**Dewberry's Response to USGS' Review**

**PAgis V13 LiDAR Processing Project**

**G10PC00013**

**G11PD01289**

*Figure 2: Tile 15WU2617, Delivery 1. Portions of the identified feature was originally interpreted as a hydro and removed from the ground surface. The LAS and DEM has been corrected by adding portions of this feature back to the ground surface, shown below.*

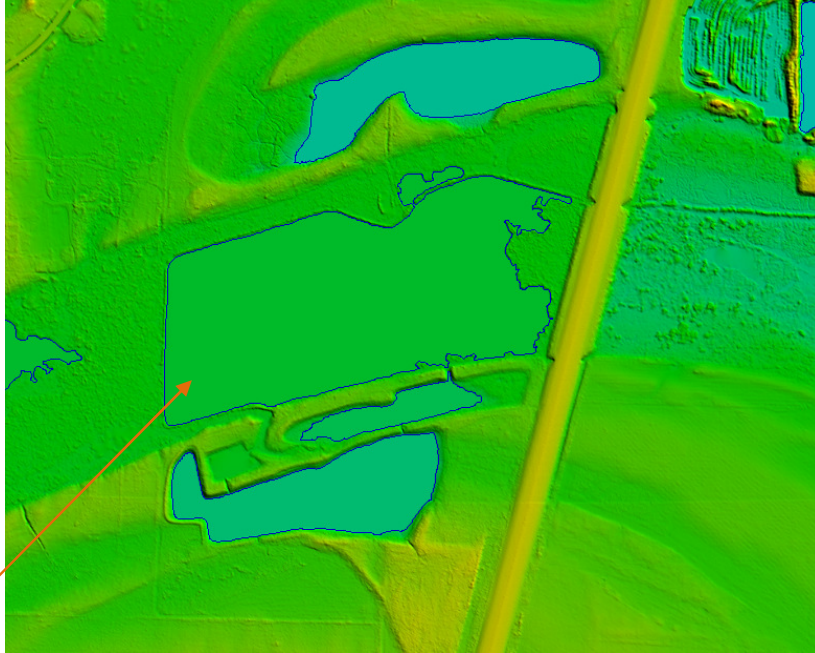
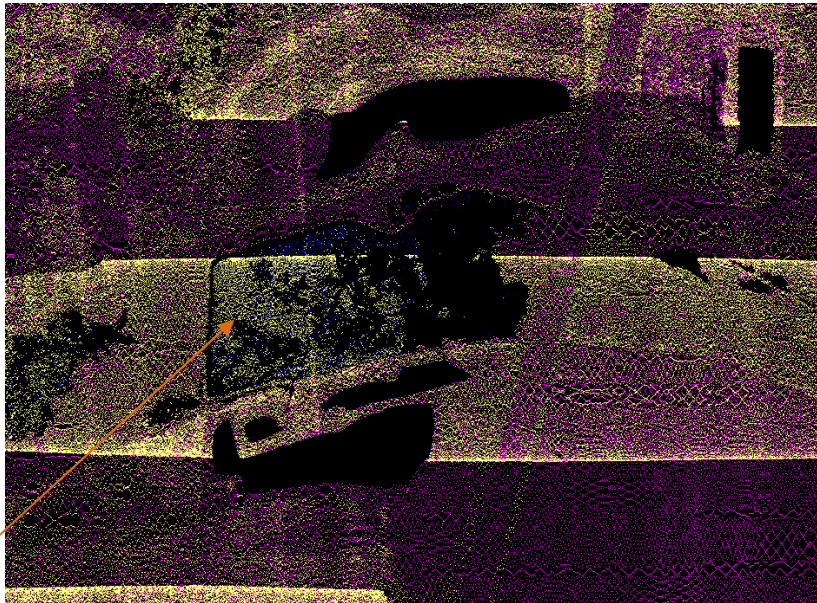
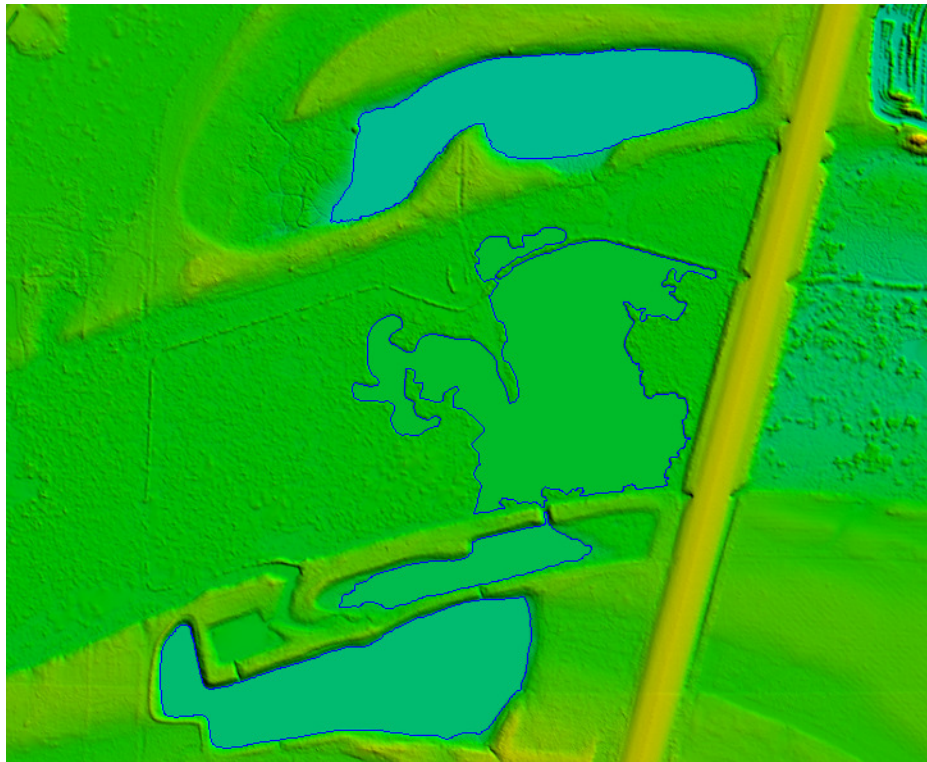
There are twenty-seven locations where Dewberry interpreted a feature as water and included the feature in the collected breaklines. USGS identified some of these features as ground, not water. USGS also identified areas of water that were not included in the collected breaklines. While the interpretation of the feature may be questionable in the intensity imagery, Dewberry agrees with twenty of the calls after reviewing color imagery. These twenty instances identified by USGS have been corrected. An example is shown below.

*Figure 3: Tile 15WU2617. The LiDAR points shown above confirm that the breaklines delivered to USGS should be modified to include additional ground data. The black area is where no points were returned due to the presence of water but the yellow points just west of the feature show several points were returned indicating the presence of ground.*

Figure 4: Tile 15WU2617. The intensity image showing the collected breaklines from the first delivery in purple and the modified breaklines from this delivery in blue.

Figure 5: Tile 15WU2617, Delivery 2. Portions of the identified feature was originally interpreted as a hydro and removed from the ground surface. The LAS and DEM has been corrected by adding portions of this feature back to the ground surface.

*Figure 6: Tile 15WU2419. As the intensity imagery shows, the breaklines delivered to USGS correctly capture existing waterbodies.*

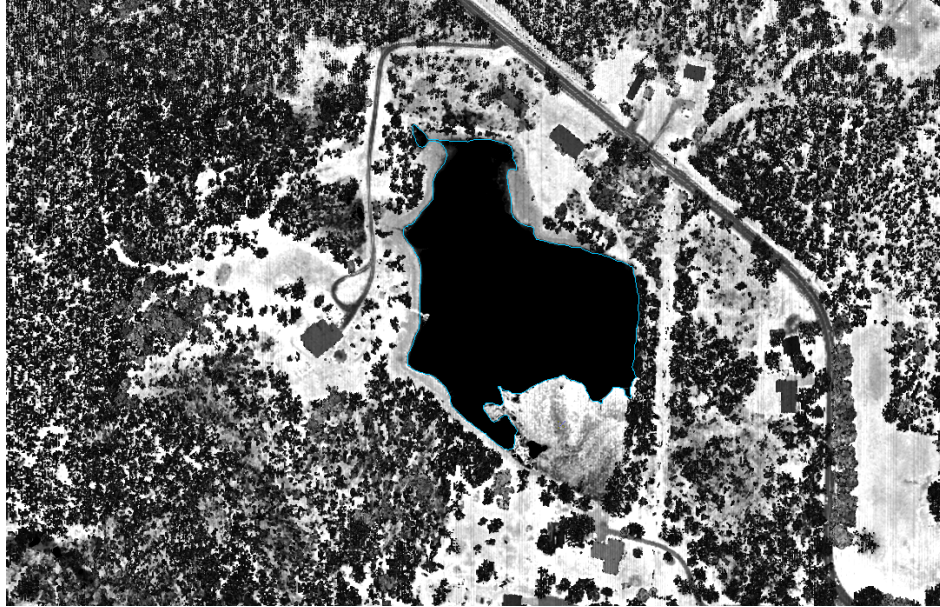
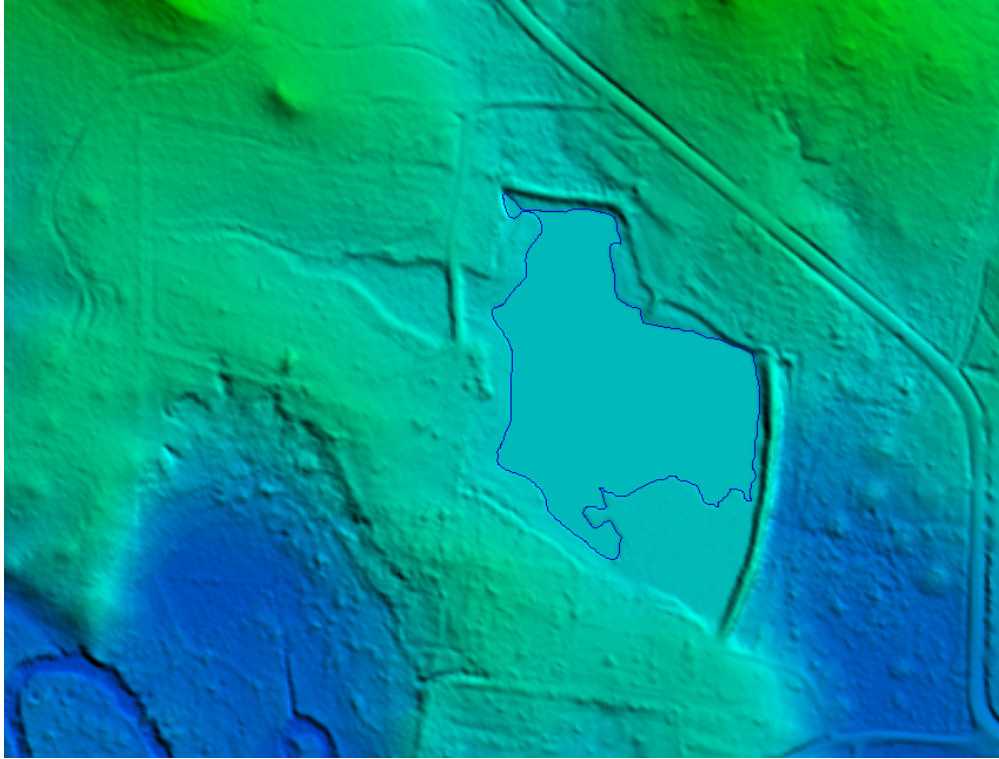
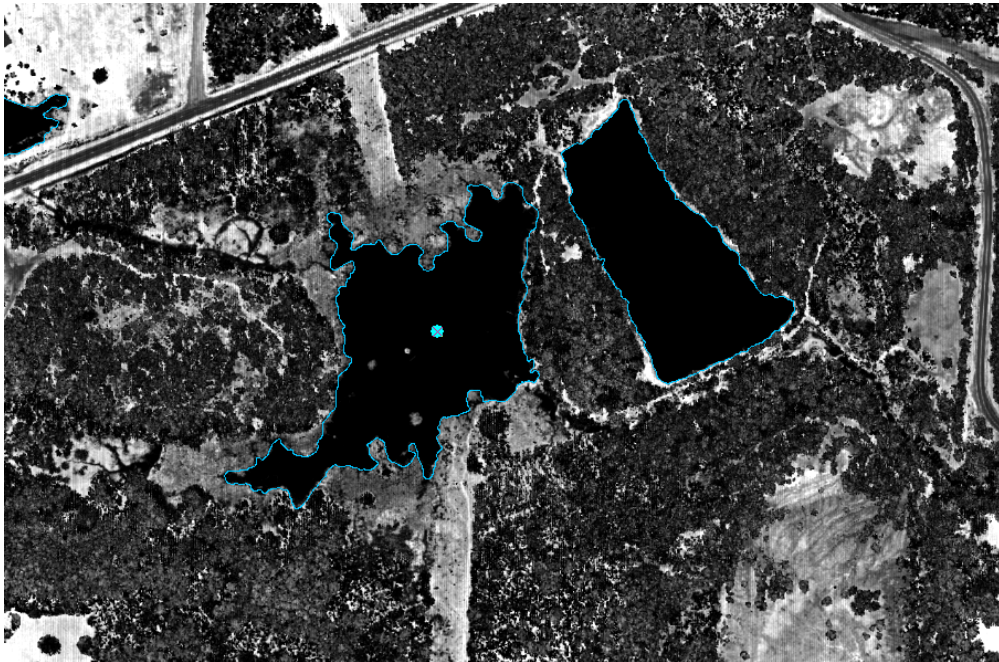
There are seven locations called out by USGS where, after reviewing the LiDAR, Dewberry confirmed that the breaklines accurately capture the existing water and no changes were necessary. Examples are shown below.

*Figure 7: Tile 15WU2419. The LiDAR points shown above confirm that the breaklines delivered to USGS correctly capture the waterbody. The black area is where no points were returned due to the presence of water but the pink points just south of the feature show several points were returned indicating the presence of ground.*

*Figure 8: Tile 15WU2419. The breaklines delivered to USGS correctly capture existing waterbodies. No change was made to the breaklines or DEM surface.*

*Figure 9: As the intensity imagery shows, the breaklines delivered to USGS correctly capture existing waterbodies. No change was made to the breaklines or DEM surface.*

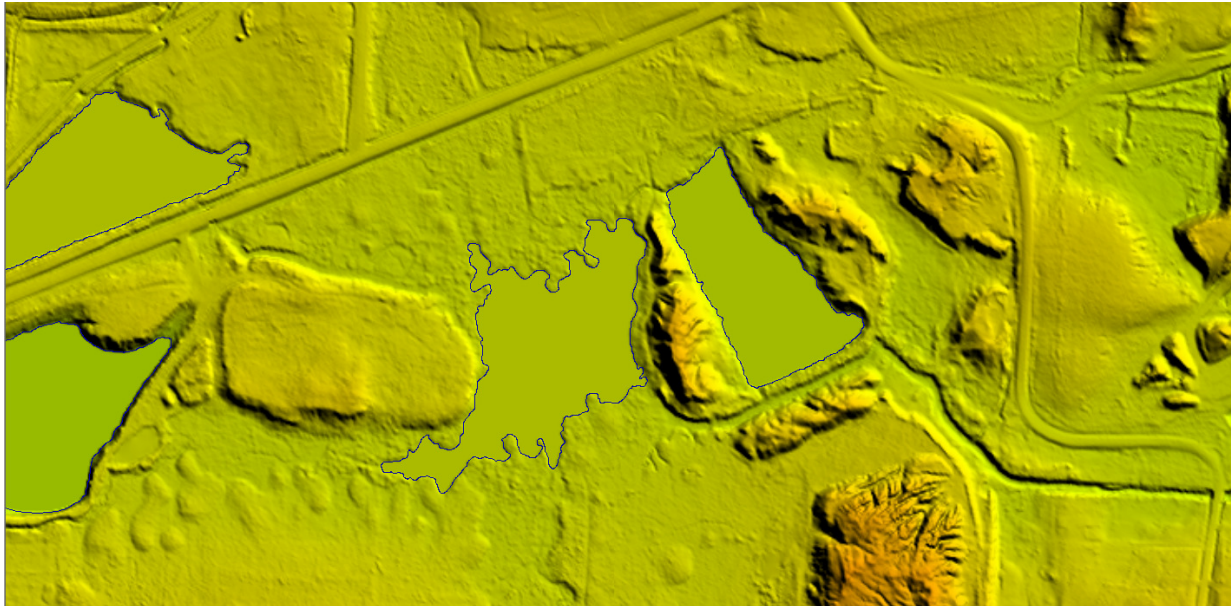
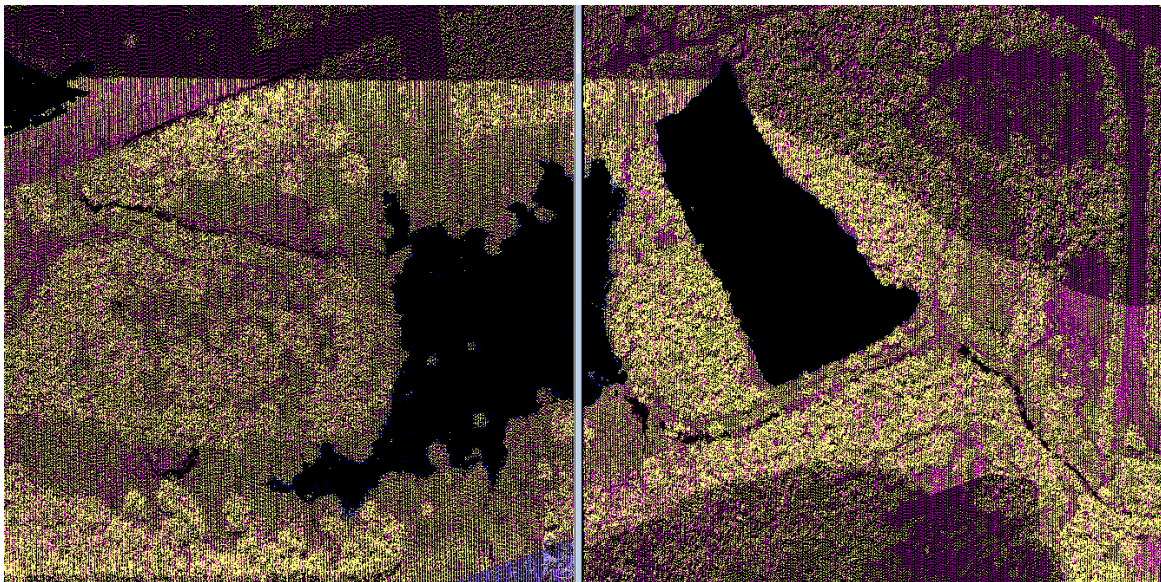
*Figure 10- Tile 15WU221 and 15WU2311. The DEM shows a visual artifact because the surface model is interpolating from the slope leading to the bridge to the hydrographic banks. The surface model must make a continuous model and in order to do so, points are connected through interpolation. This can cause visual artifacts when there are features with large elevation differences.*

*Figure 11- Tile 15WU221 and 15WU2311. The profile view shows the LiDAR points, colored by class, of this particular feature. All bridge points have been removed from ground (pink) and are unclassified (yellow). There are no ground points that can be modified to correct this visual artifact.*

Figure 12- Tile 15WU2322, Delivery 1. The feature identified was originally interpreted as a bridge and removed from the ground surface. USGS identified this feature as a culvert. The LAS and DEM has been corrected by adding this feature back to the ground surface, shown below.

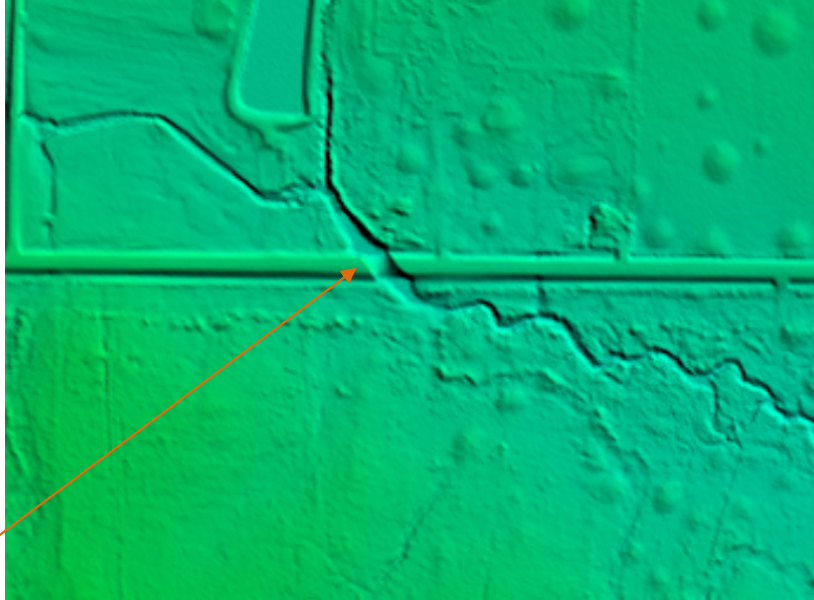
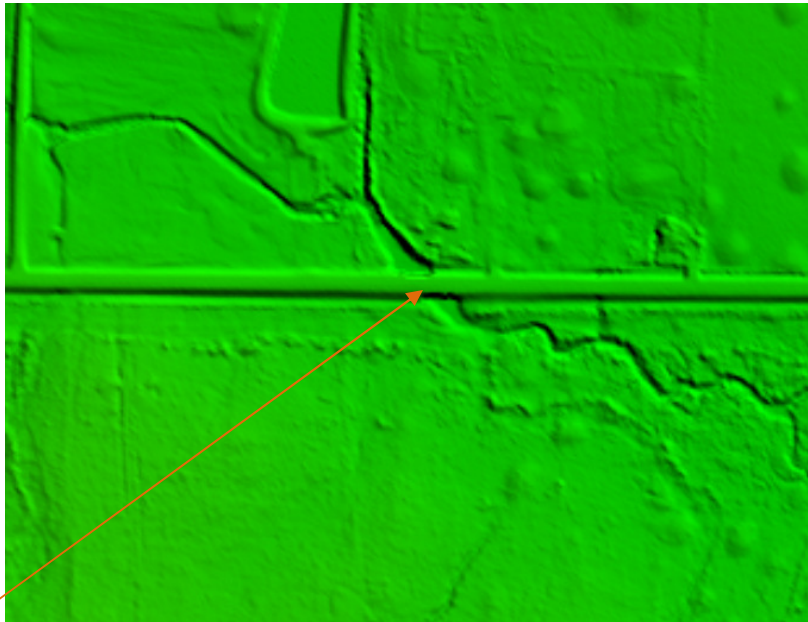
There are eight locations where Dewberry interpreted a feature as a bridge and removed the feature from the ground surface. USGS identified these features as culverts, not bridges. Dewberry agrees with all eight calls and all eight instances identified by USGS have been corrected. An example is shown below.

Figure 13- Tile 15WU2322, Delivery 2. The culvert has been added back to the ground surface.

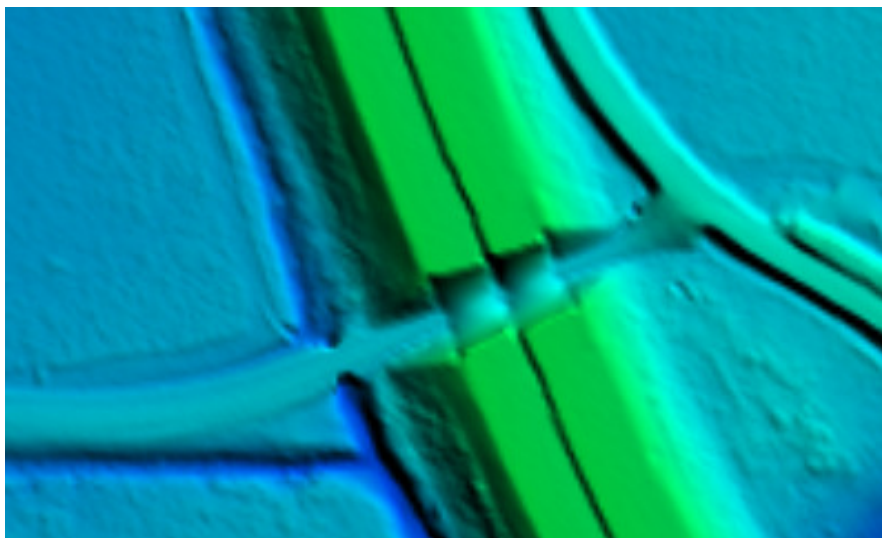
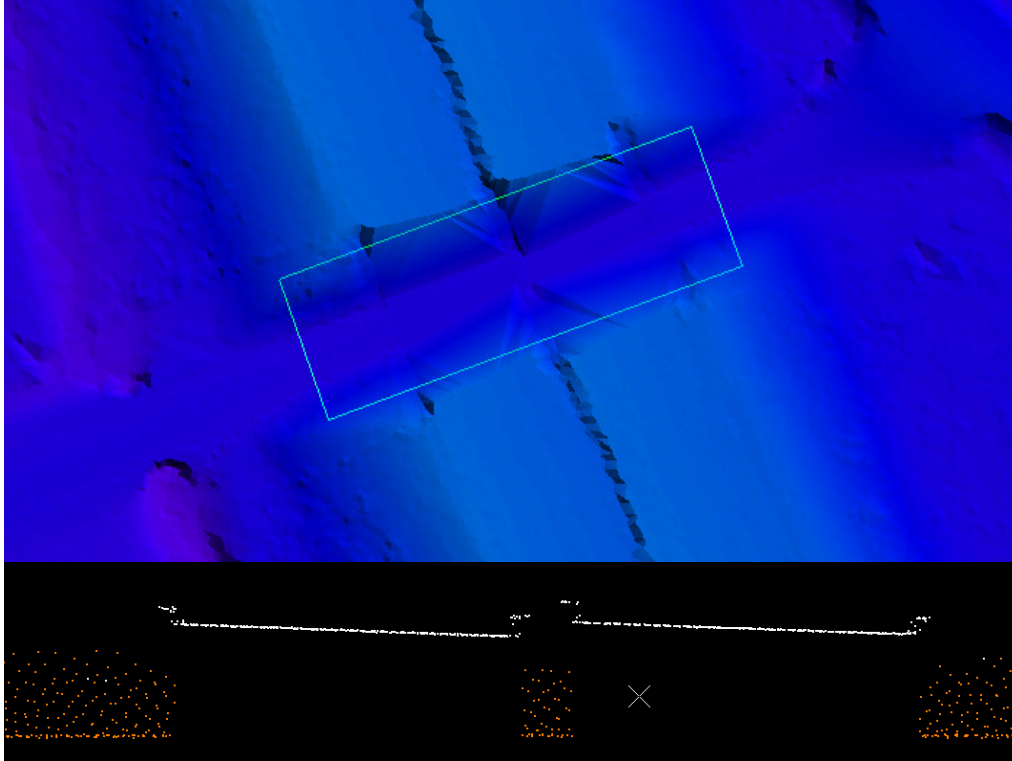
There are twenty locations where comments were made for bridge removal artifacts. The DEM surface models are created from TINs or Terrains. TINs and Terrain models create continuous surfaces from the inputs, in this instance LiDAR ground points and breaklines. Because a continuous surface is being created, the TIN or Terrain will use interpolation to triangulate across a bridge opening from legitimate ground points on either side of the actual bridge. This can make the model appear to contain a bridge even though points have been removed from ground. This can also cause visual artifacts or “saddles,” as labeled in the USGS review document. As these “artifacts” are only visual and do not exist in the LiDAR points or breaklines, no modifications were made to the LAS or DEMs in these areas. Examples are shown below.

*Figure 14- Tile 15WU1822. The DEM above shows a visual artifact, or “saddle” as labeled in the USGS review report, because the surface model is interpolating across the bridge gap. The surface model must make a continuous model and in order to do so, points are connected through interpolation. This can cause visual artifacts or loss of detail when the surface model must interpolate across removed features, such as bridges, where there are few or no ground LiDAR points.*

*Figure 15- Tile 15WU1822. The DEM in the top view shows a visual artifact because the surface model is interpolating from the slope leading to the bridge to the hydrographic banks. The surface model must make a continuous model and in order to do so, points are connected through interpolation. This can cause visual artifacts when there are features with large elevation differences. The profile in the bottom view shows the LiDAR points, colored by class, of this particular feature. All bridge points have been removed from ground (orange) and are unclassified (white). There are no ground points that can be modified to correct this visual artifact.*
